MEMORANDUM

To: Salt Lake City Historic Landmark Commission

Date: May 3, 2018

Re: Liberty Square Apartments PLNHLC2017-00266 & PLNHLC2015-00237

SHEET NO. A2.1

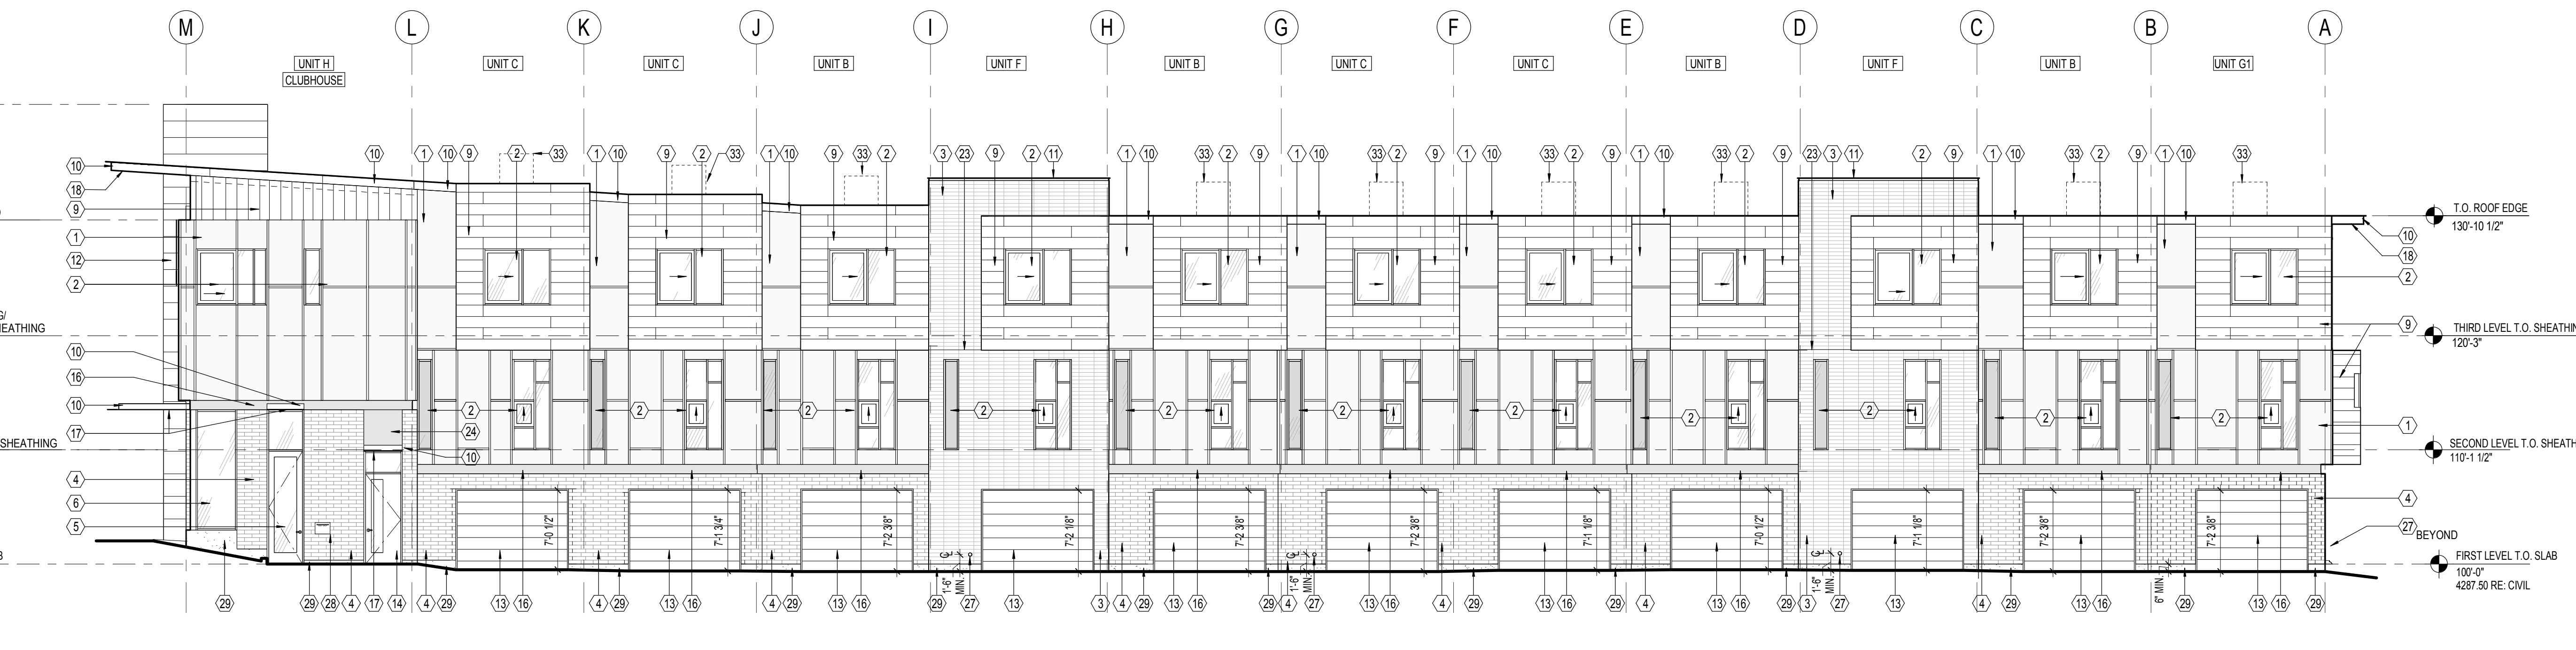
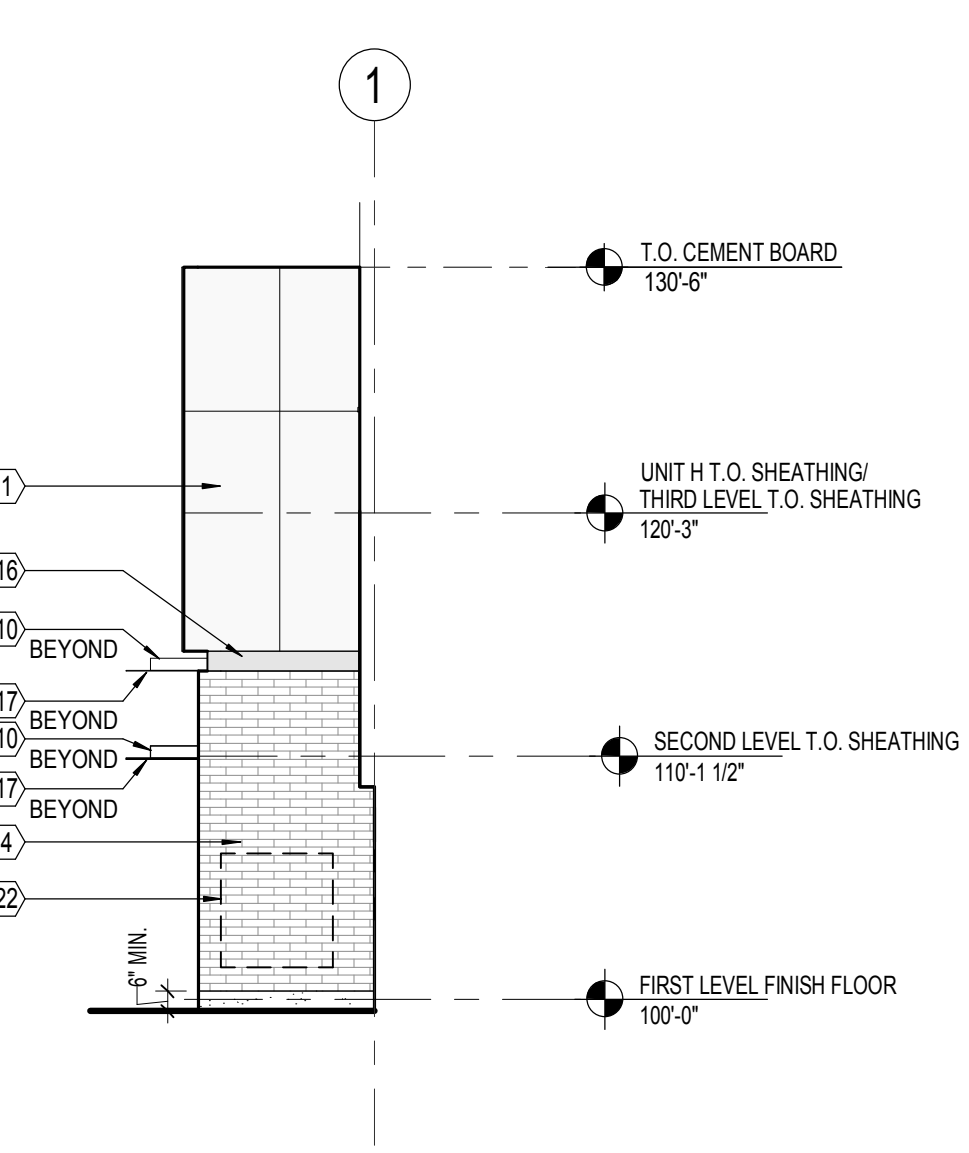
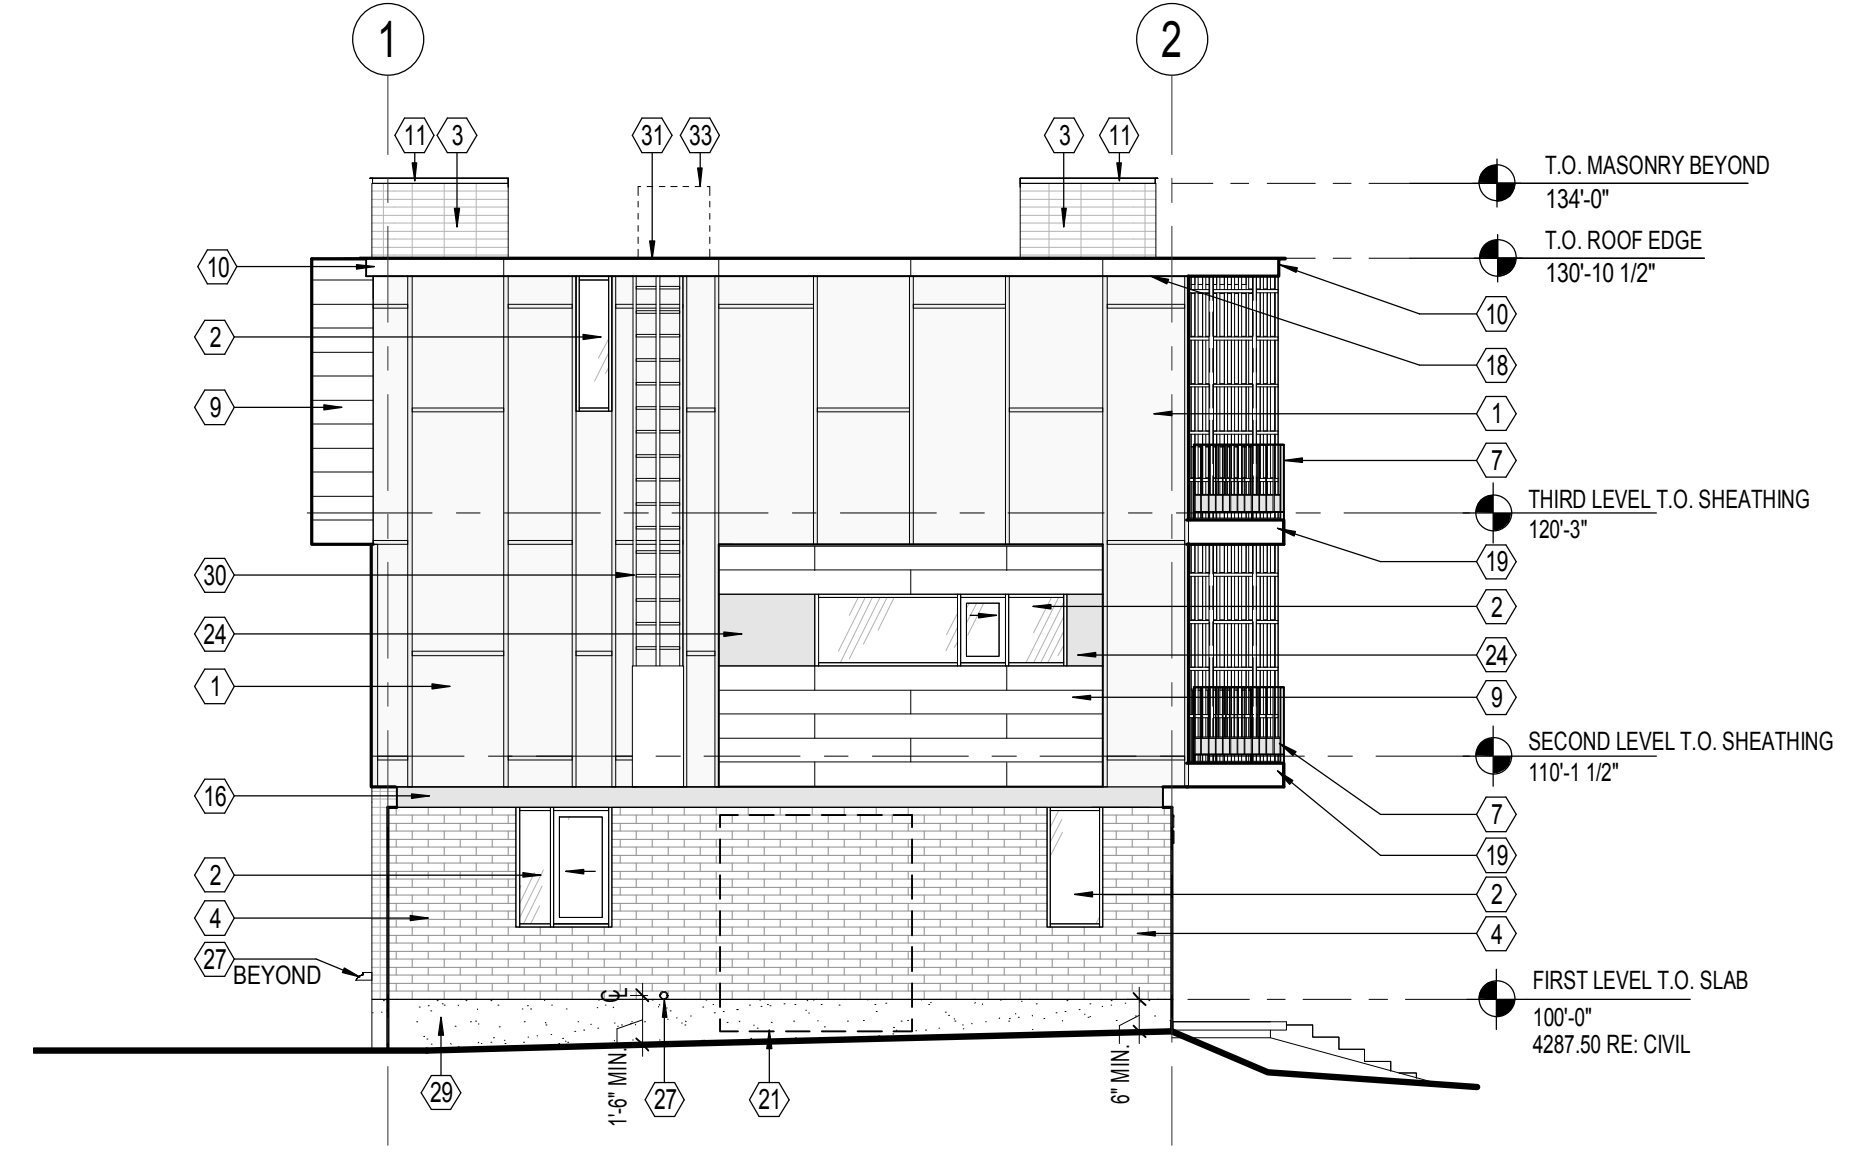
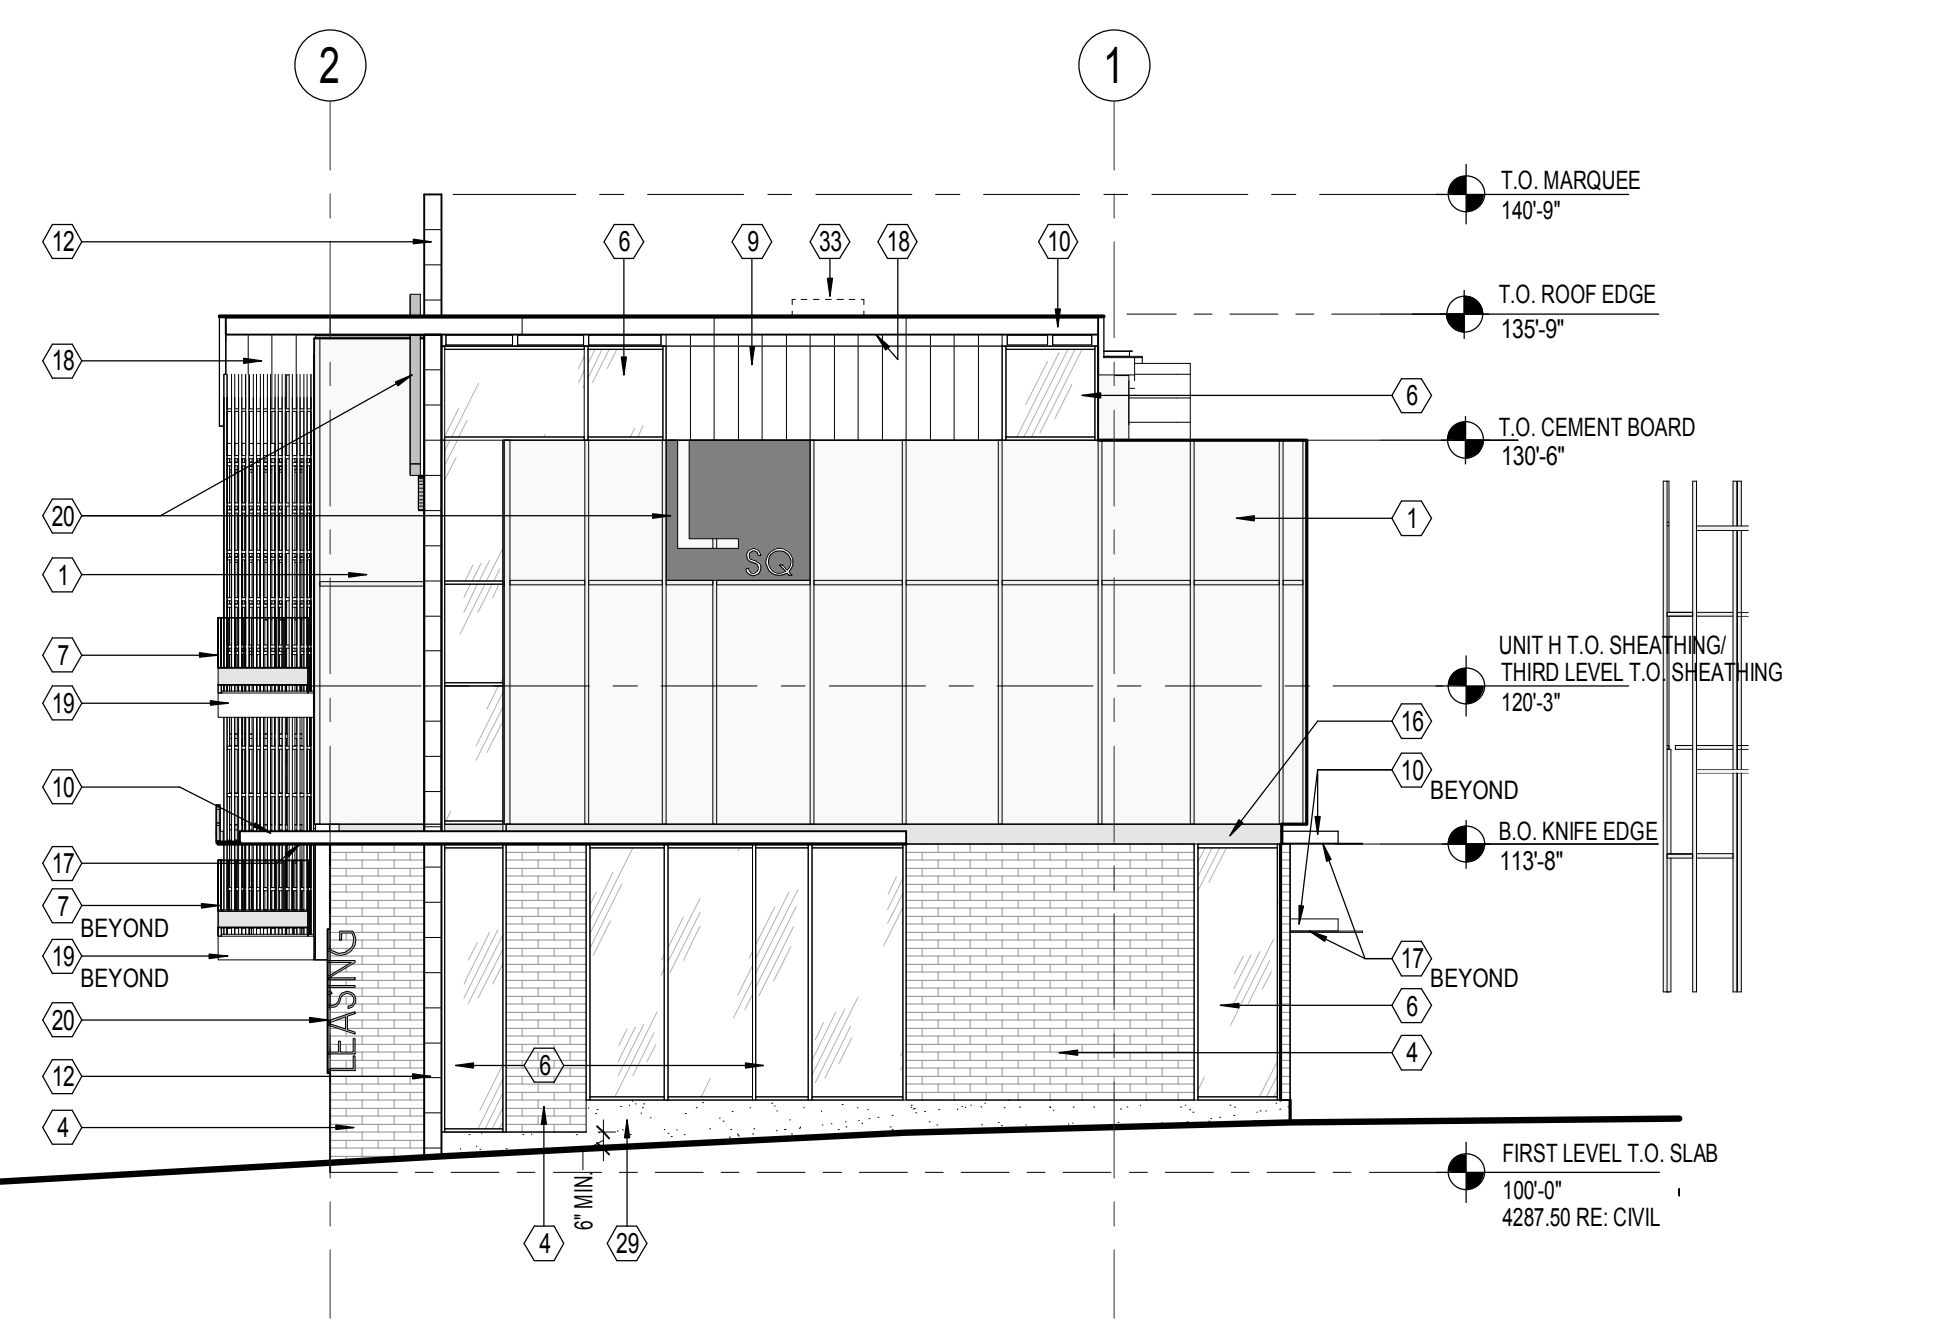
The cedar soffit has been revised to a metal soffit to match the fascia, which emphasizes the strong horizontality of the projected eaves. Refer to the attached Exterior Elevations for Buildings 1 – 8 drawings A2.1 – A2.5.

The "roof feature" at the corner eave on the east elevation of Building 1 in the June 2017 HLC submittal provided latticed openings on the edge of the roof eave that obscured any visual reference to the development signage above, particularly from street level. In effort to provide visual reference to the development signage and better articulate the development's corner presence on 500 South and Green Street, the current design proposal includes latticed openings within the roof plane that actually allow the signage and daylighting to continue down the face of the building accentuating the clubhouse entrance and building corner.
